**HMC ARCHITECTS
3546 Concourses Street
Ontario, California 91764**

Arvin High School ESSER III Phase 1 Roofing

Kern High School District

File No: 15-H3 A#03-122508

A10.40 Roof Details

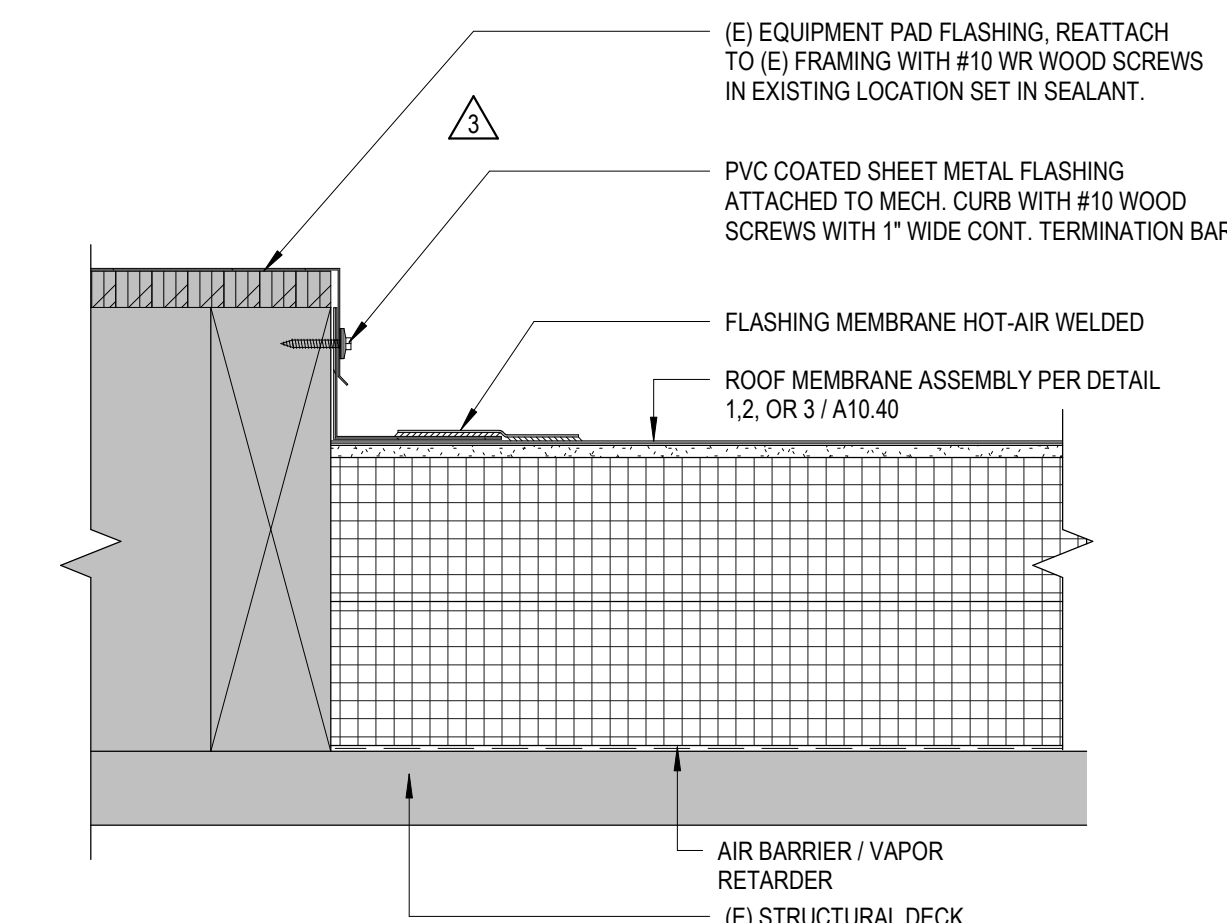
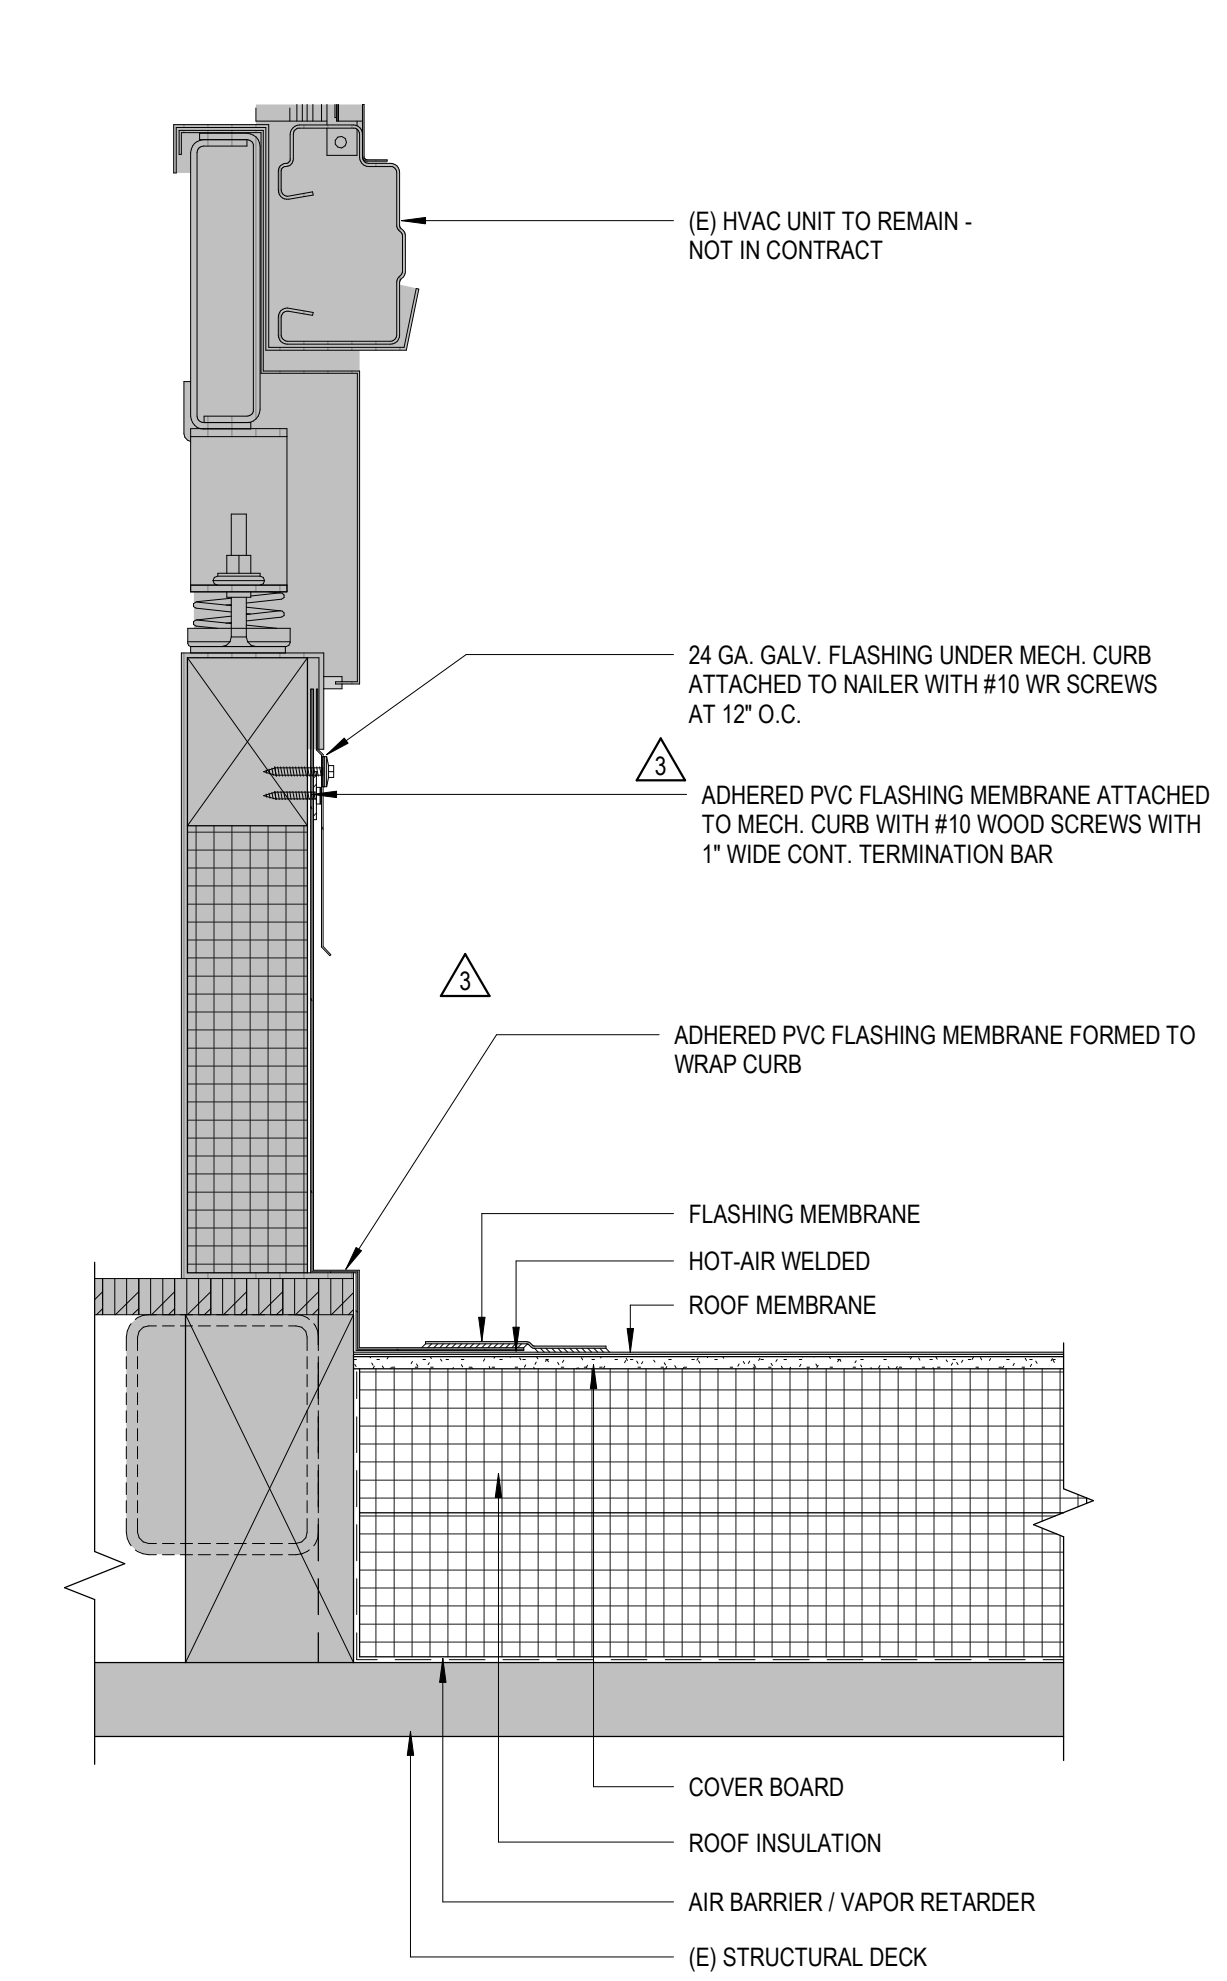
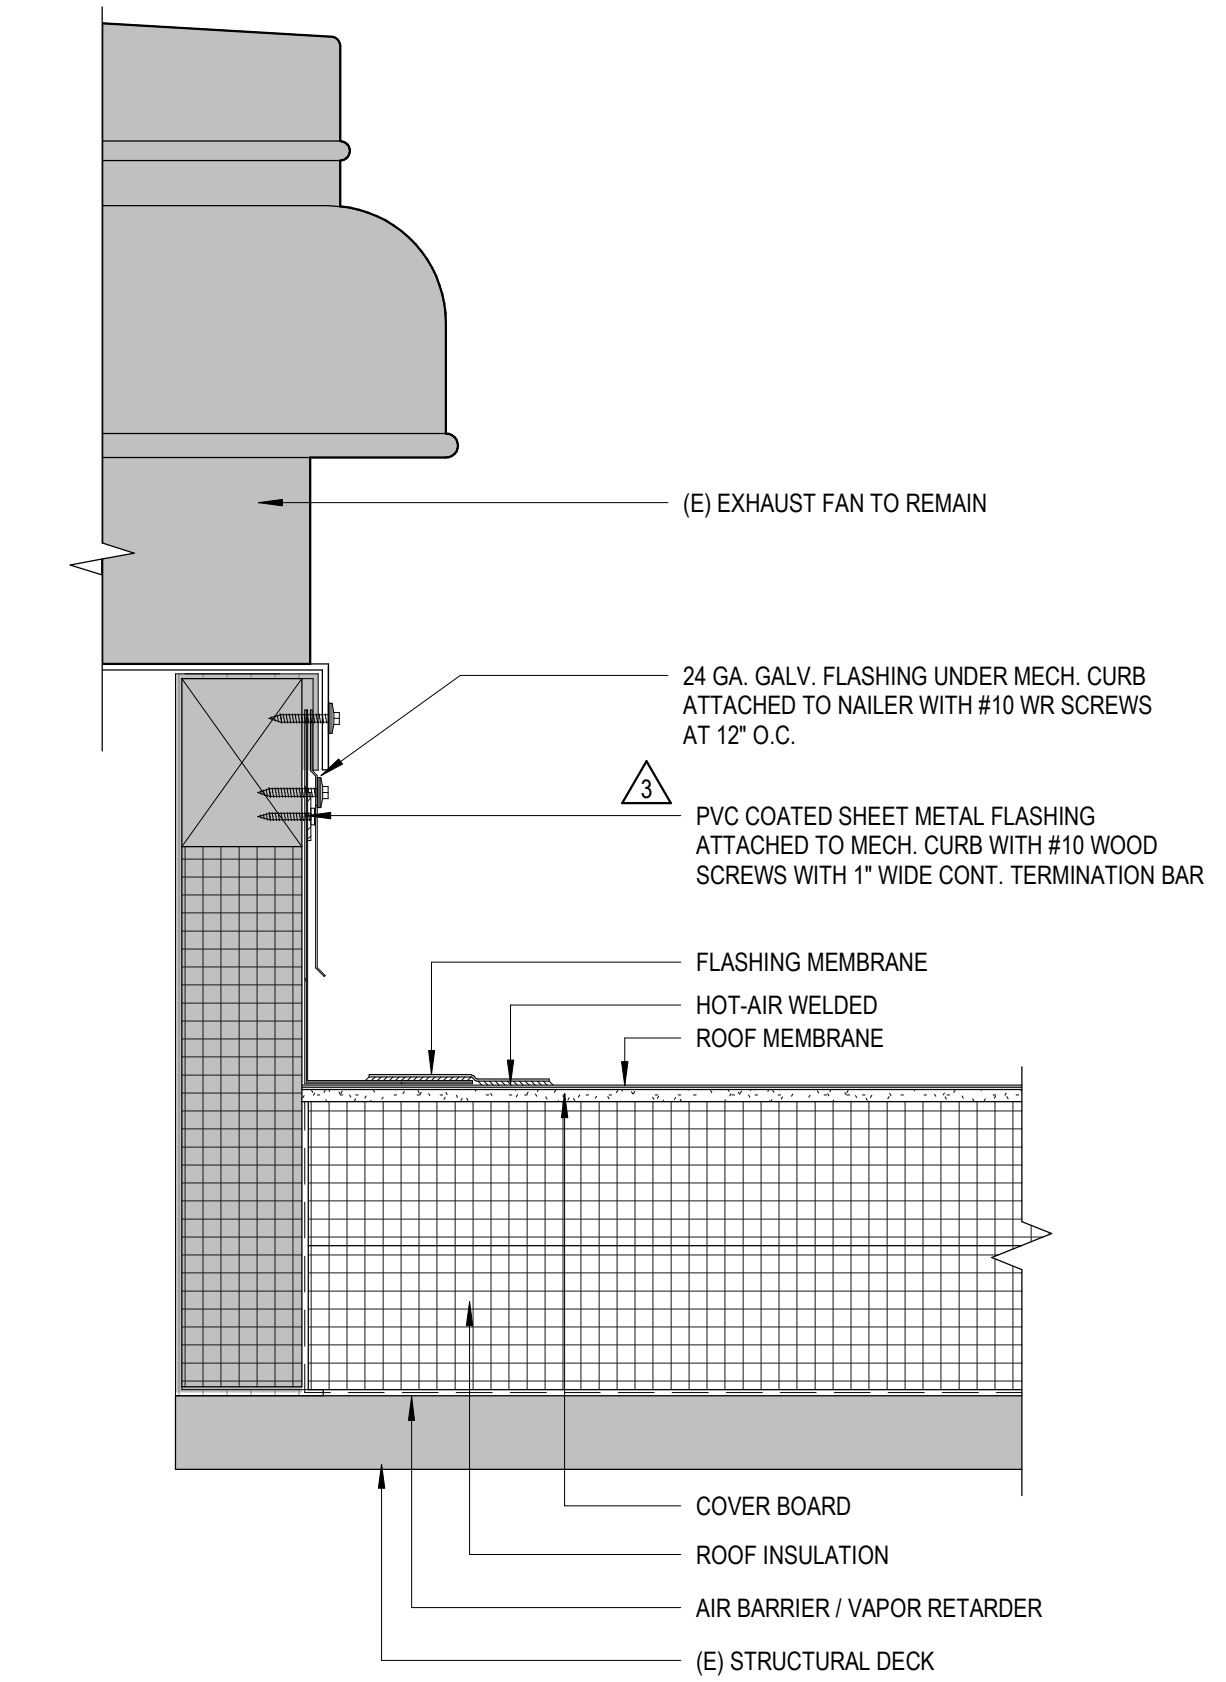
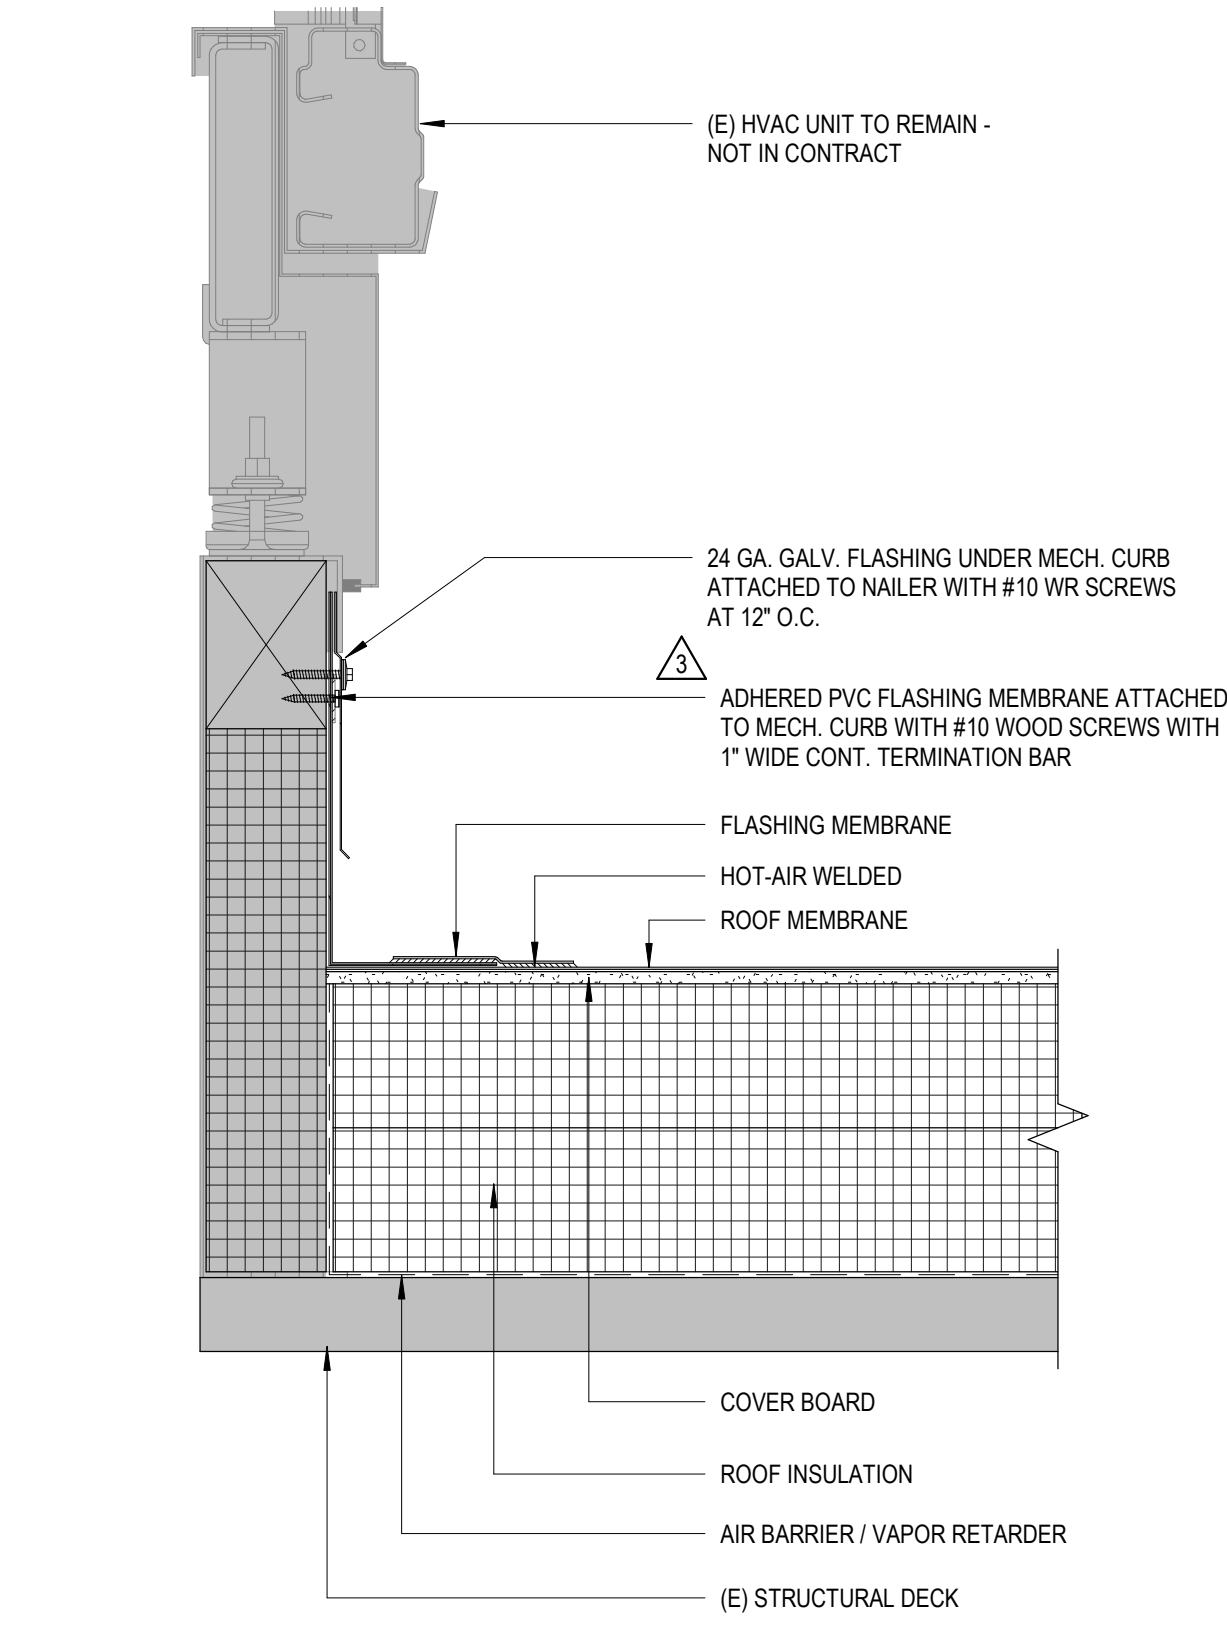
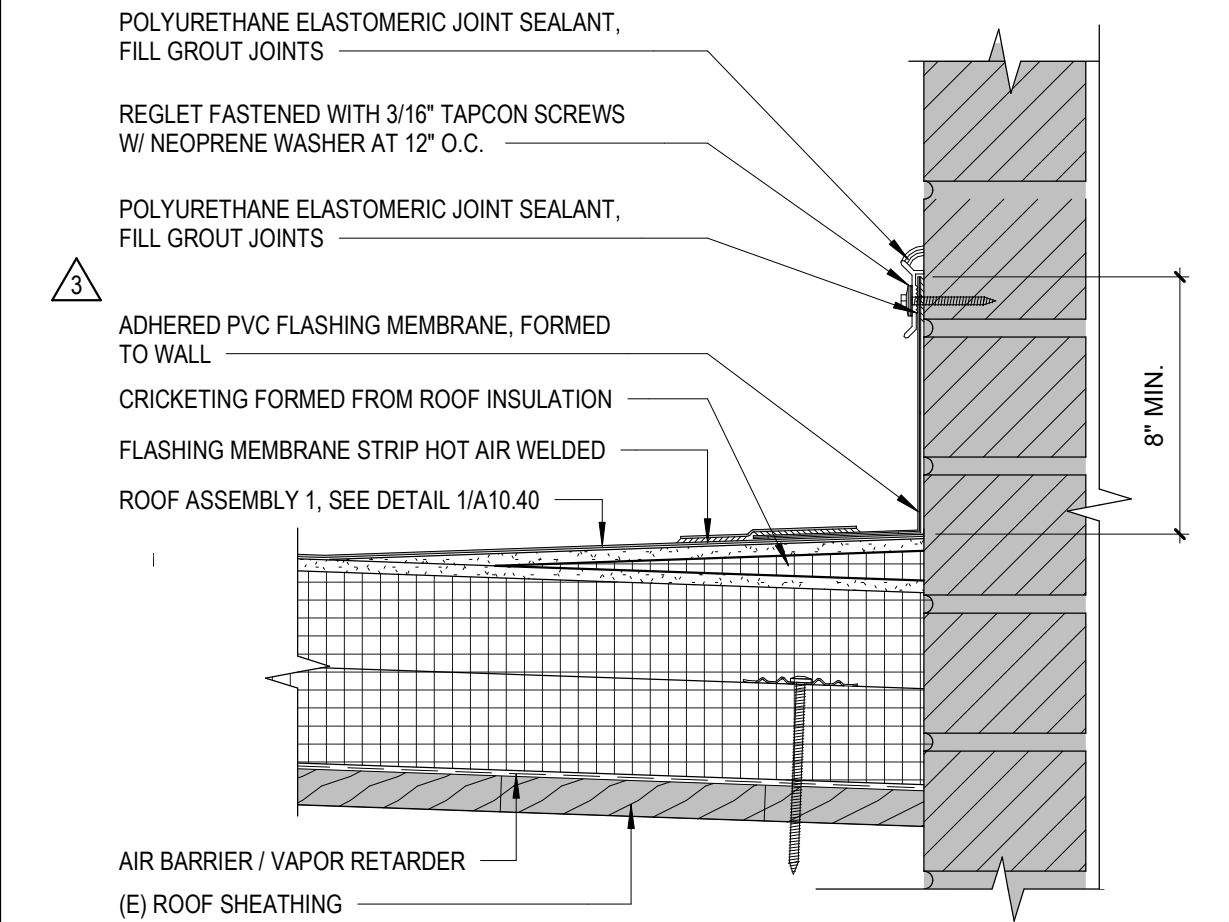
- 1.) DELETE cant strip as shown and clouded per Delta 3.
- 2.) MODIFY PVC Coated metal flashing to Adhered PVC Flashing Membrane on Detail 8, 9, 10, 14, 19, 21 & 23 as shown and clouded per Delta 3.
